A D D E N D U M

Re: Addendum 4

Locker Room and Bathroom Renovations

160 Joan Street
Springfield

Drawing No.
AD-1.1
of
Total Sheets

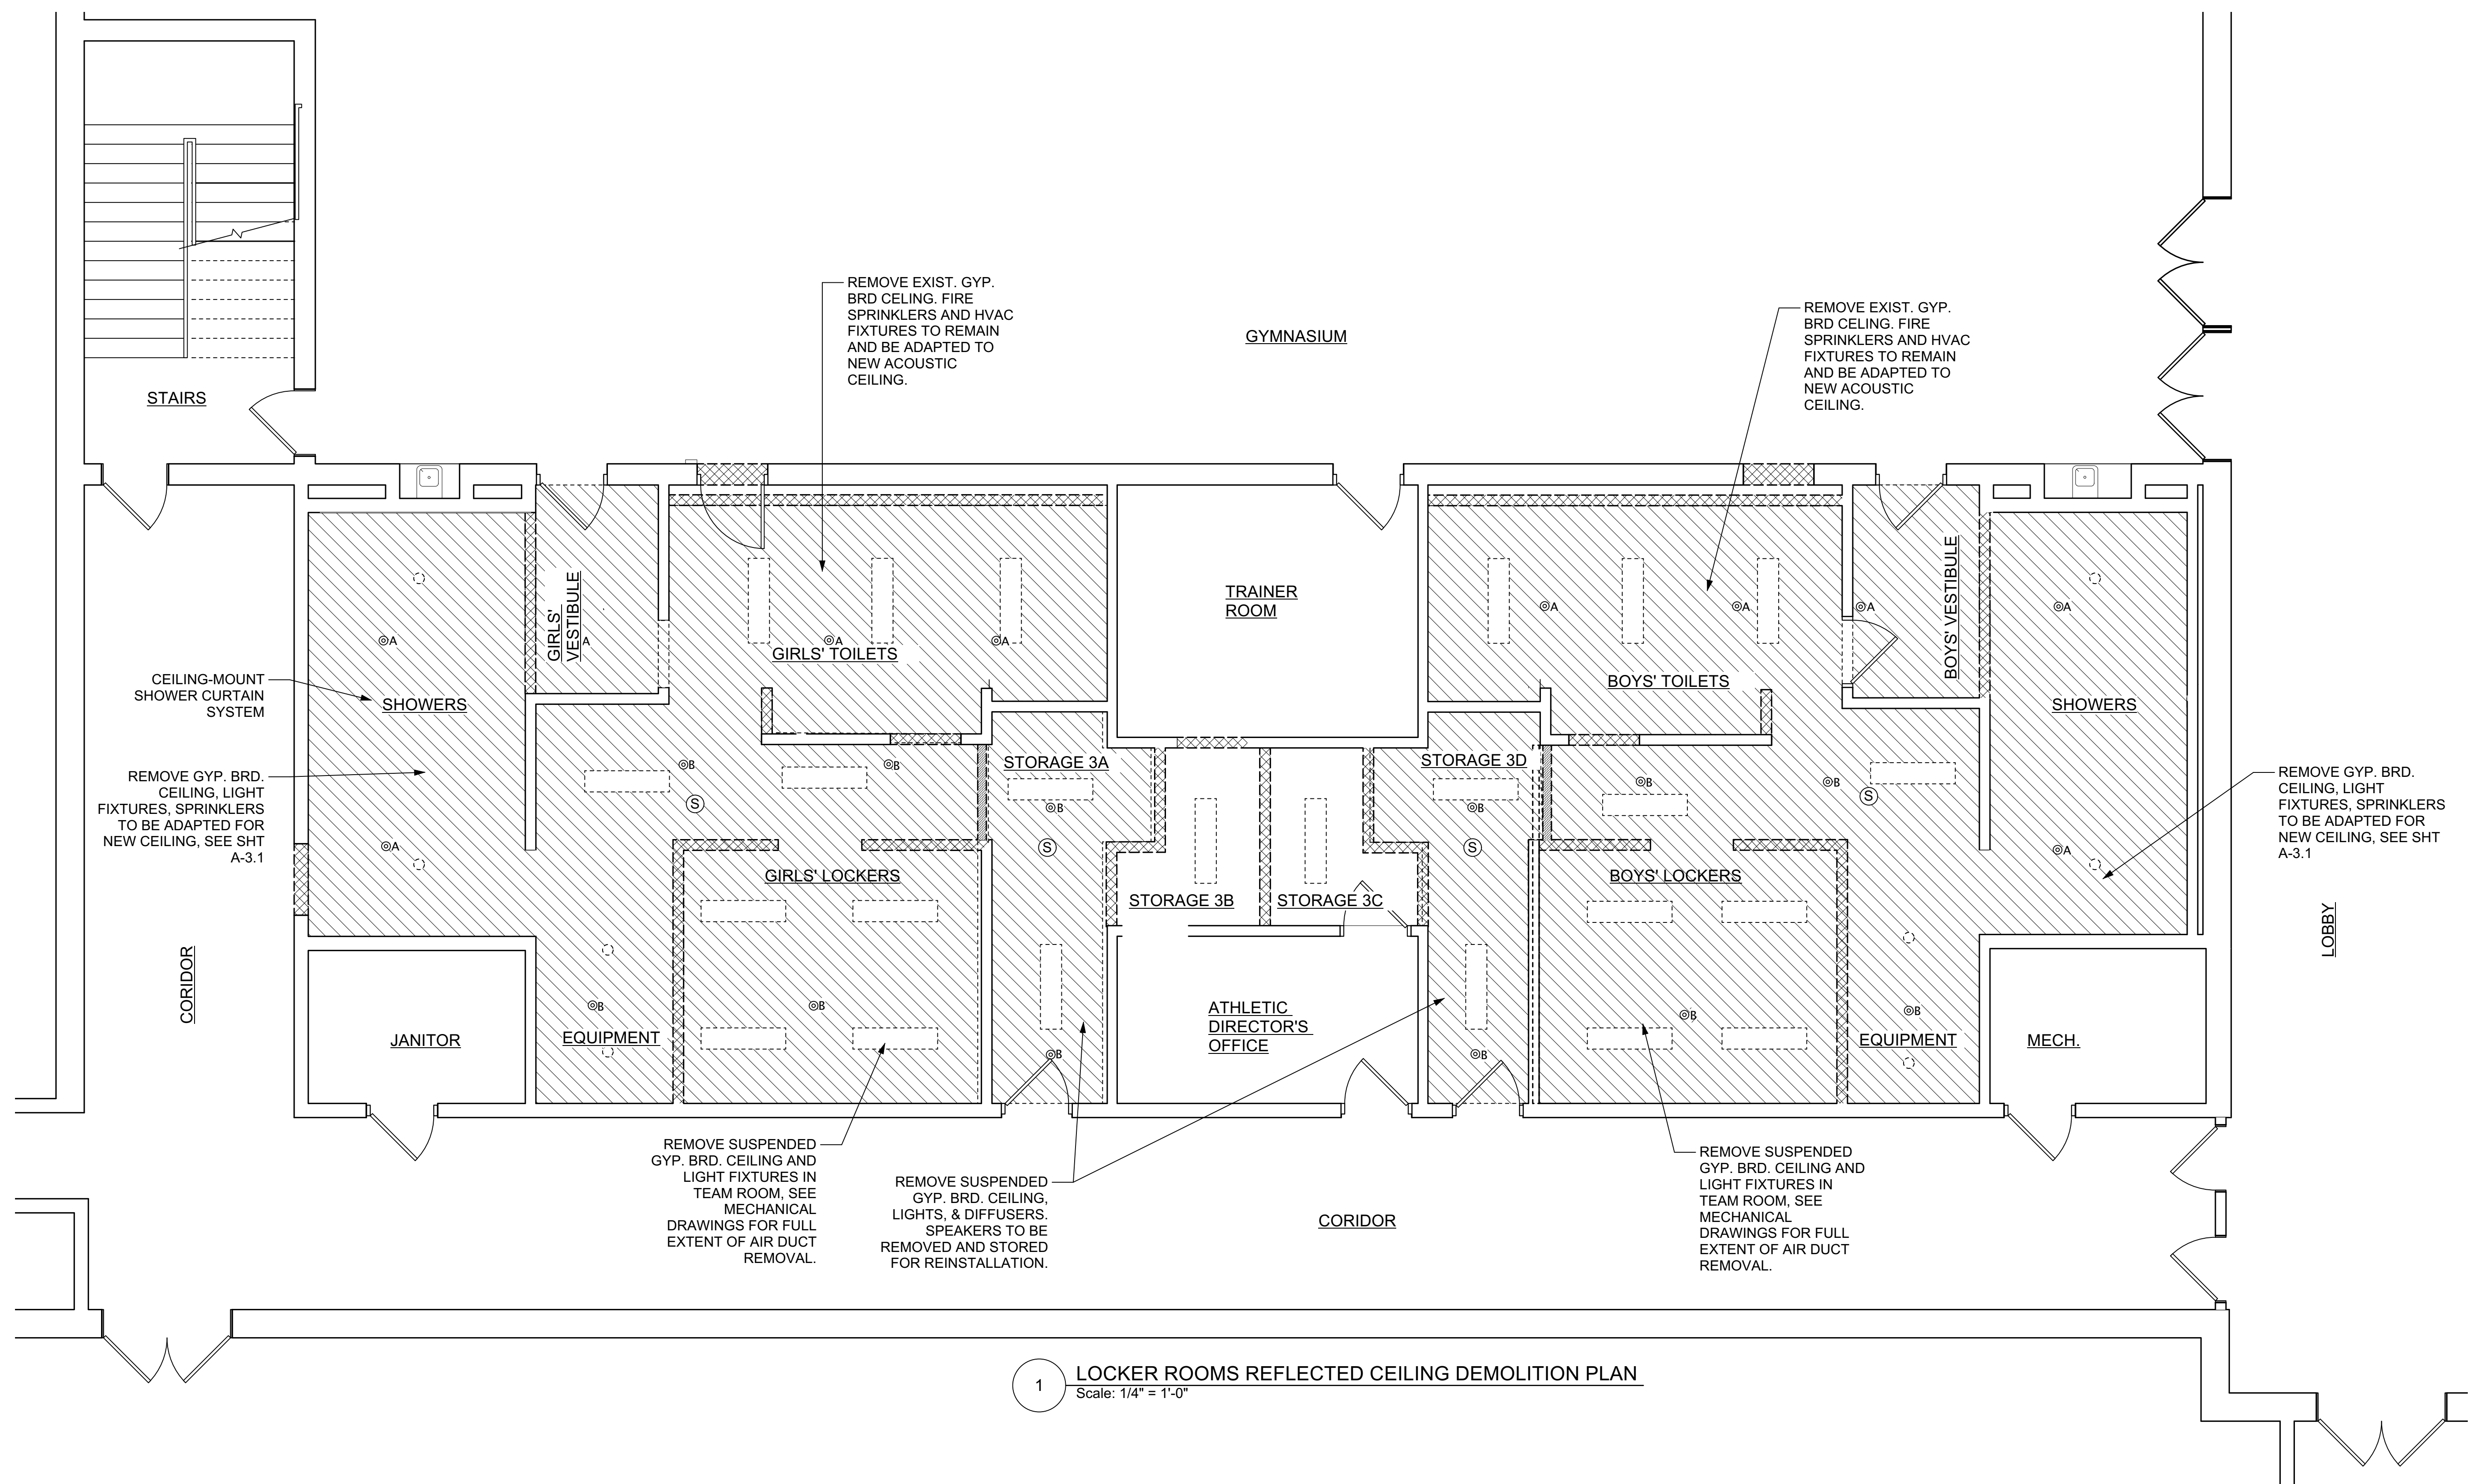
Item 1: Please see attached revised drawings: AD1-1, A1-1 & A3.0. These drawings have been revised to show scope of work related to existing fire sprinkler heads.

Revisions:
6/6/23 Addendum 4: Fire sprinkler information added

EXTG. FIRE SPRINKLER TO BE MAINTAINED AND ADAPTED TO NEW ACOUSTIC TILE CEILING
	TURN TEES UP, ADD NEW PIPE OF SAME MATERIAL AS ORIGINALLY INSTALLED TO SET NEW UPRIGHT FIRE SPRINKLER 12" BELOW UNDERSIDE OF EXTG. DECK ABOVE, 12'8" +/- - SEE DRAWING 1, SHEET A3.0

Drawing No.
A-1.1
of
Total Sheets

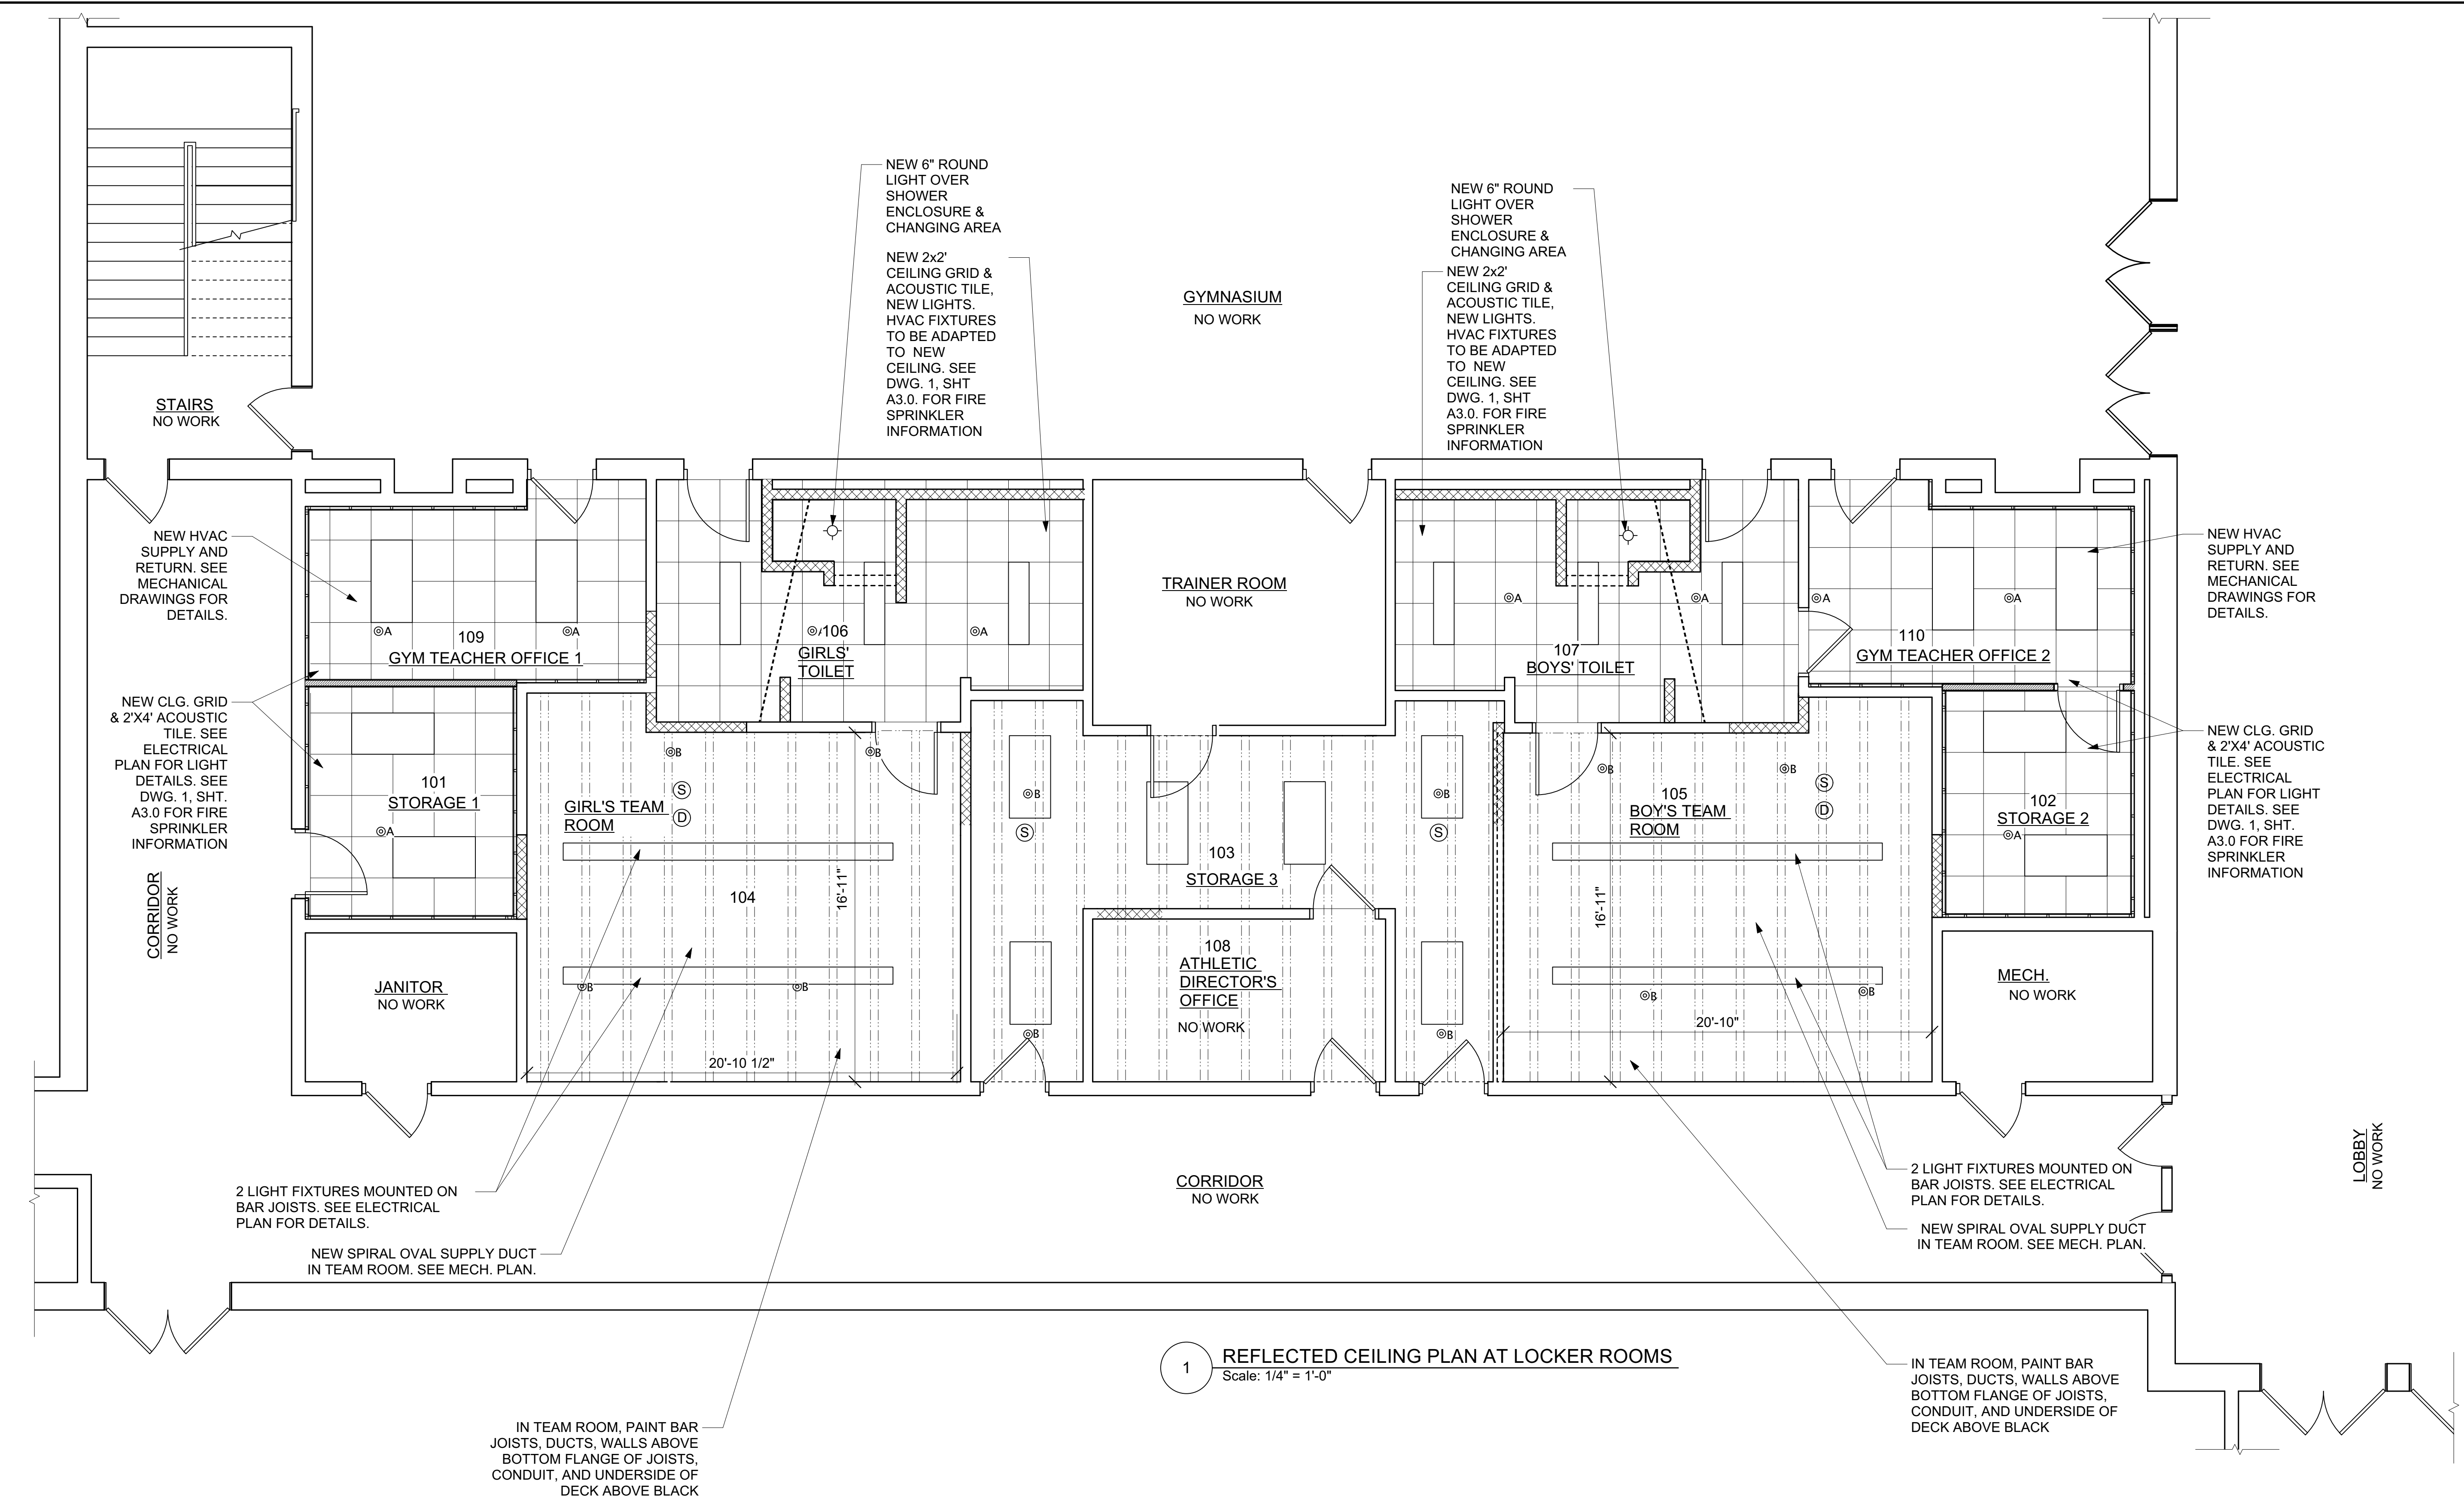
Revisions:
6/6/23 Addendum 4: Fire sprinkler information added

SECTION @ LOCKER ROOMS

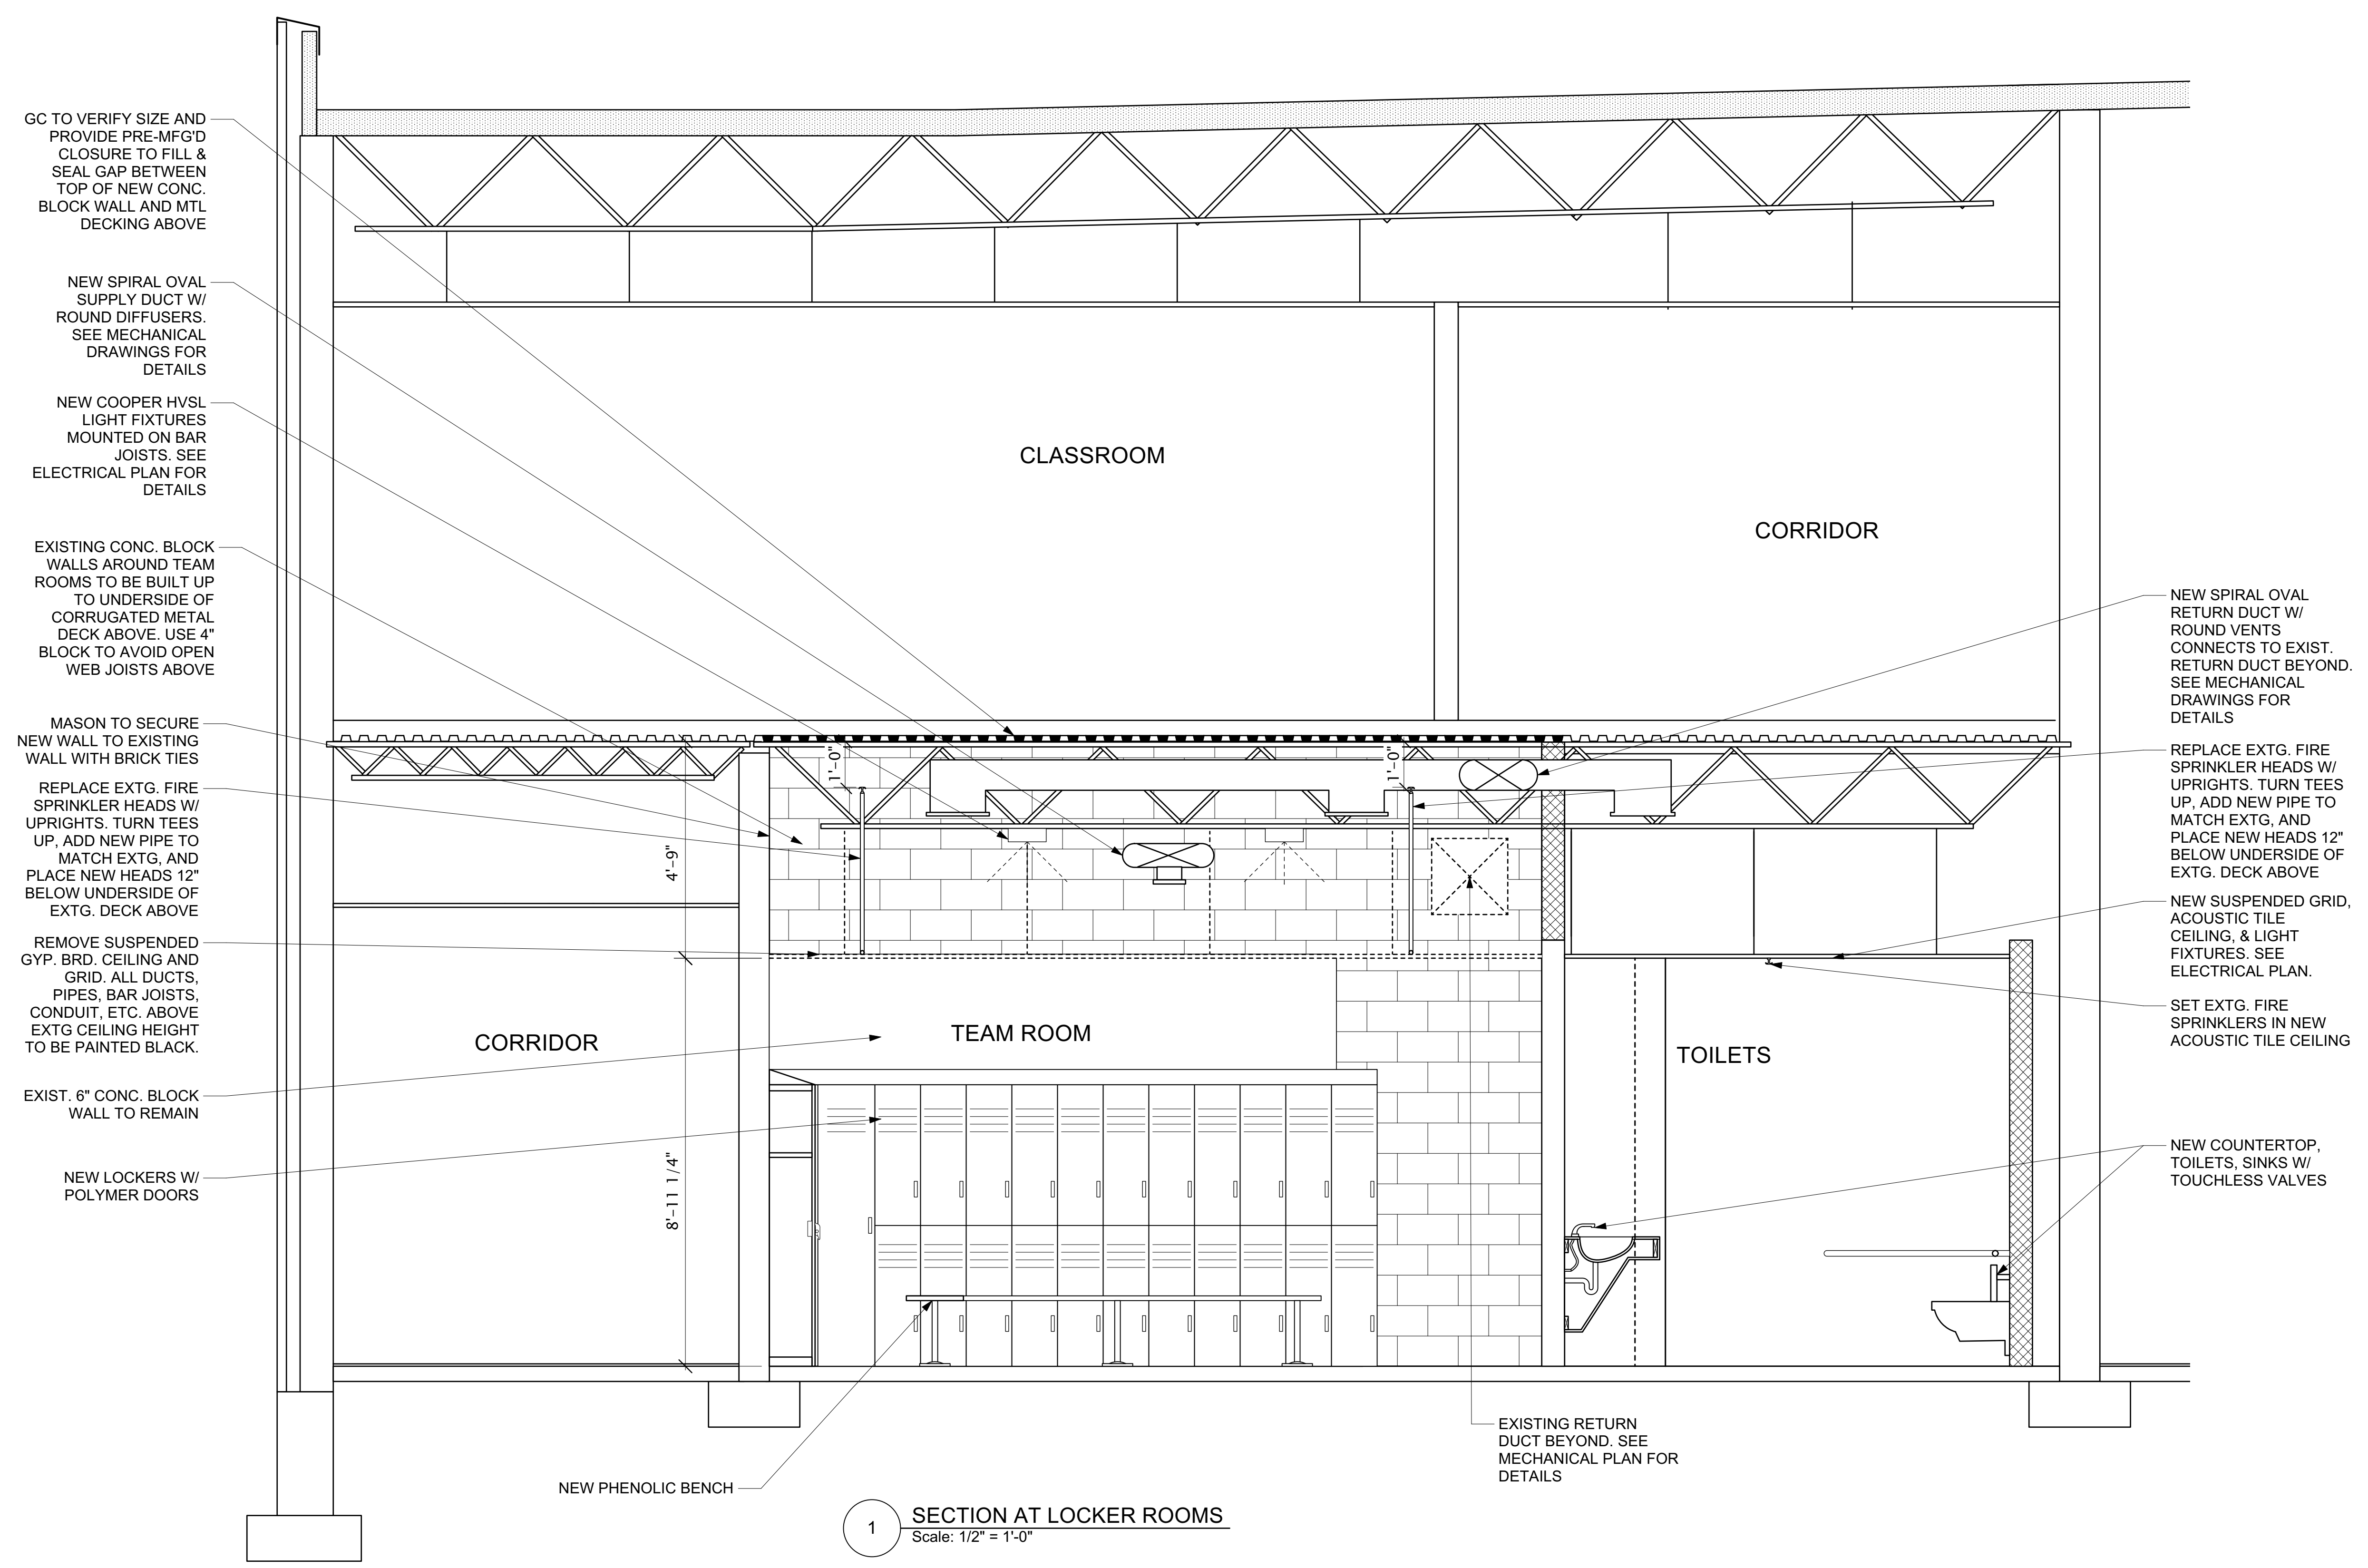
Revisions:
6/6/23 Addendum 4: Added fire sprinkler information
